Warranty Field Campaign

Campaign Number: c2024	Revision:	Released Date: 01-May-2018
L9 2017 VG Turbo Speed Sensor Harness Routing Campaign		Expiration Date (U.S. and Canada): 27-Apr-2020
		Expiration Date (International): 27-Apr-2020

L9 2017 VG Turbo Speed Sensor Harness Routing Campaign

L9 Turbo speed sensor harness routing

Image A – Incorrect routing

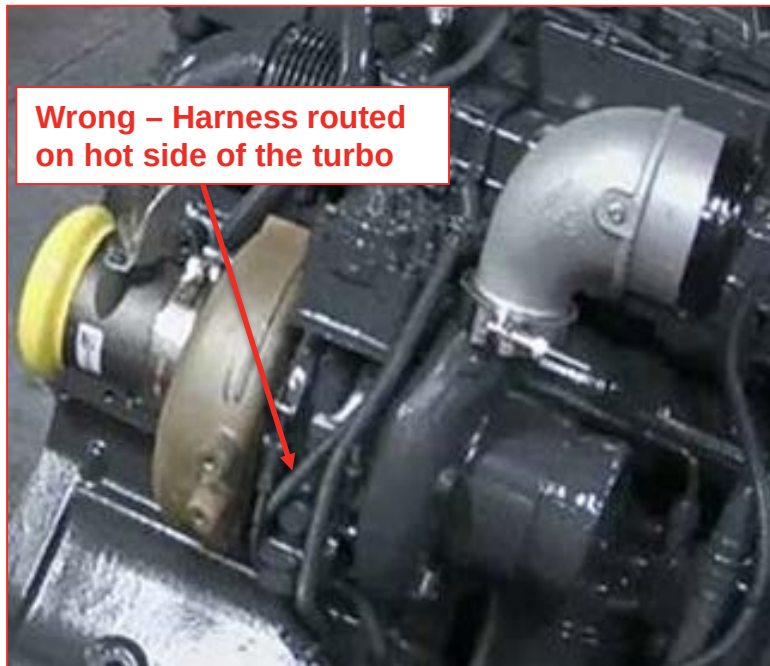
This campaign is being issued to address an incorrectly routed turbocharger speed sensor harness on certain L9 CM2350 L116B Engines, and authorizes the field to replace the harness and route correctly.

1. Remove and Install the Turbo speed sensor harness PN 4034198. Please refer to the L9 CM2350 L116B Service Manual, Section 019-390 Turbocharger Speed Sensor.
2. Please refer to Attachment B. Route the new harness as illustrated in Routing Image B.
